Mt Iron Junction Housing Scheme

Comment from Adjacent Neighbours (FTAA-2602-1173)

Figure 1.1 – Site and surrounding area

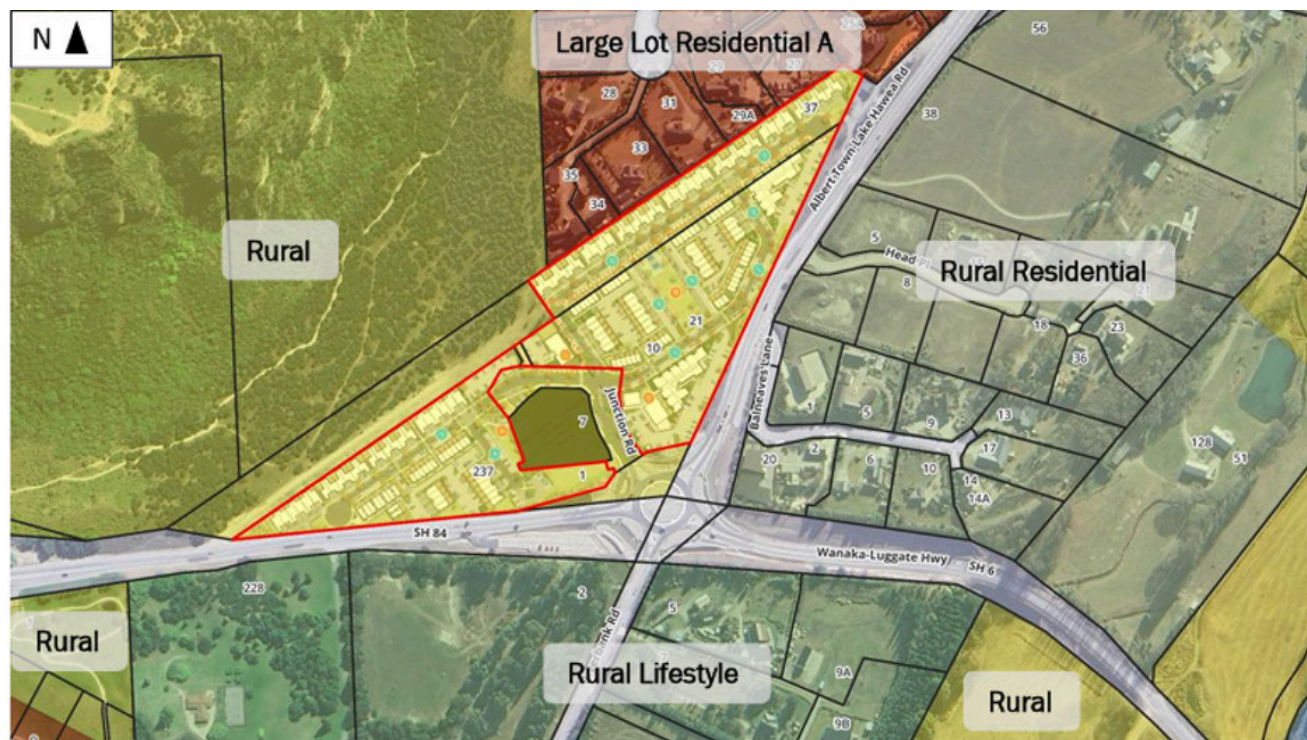
As shown in Appendix U, Figure 1.1, the site is surrounded by:

- Large Lot Residential A

- Rural Residential
- Rural Lifestyle
- Rural Zones

Placing a **high-density development in the middle of rural zones** is inconsistent with:

- The **National Policy Statement on Urban Development (NPS-UD)**, which seeks intensification **within existing urban environments**, not outward sprawl.
- The likely future intensification enabled within the **CBD and Three Parks**, where infrastructure and zoning already support higher density.
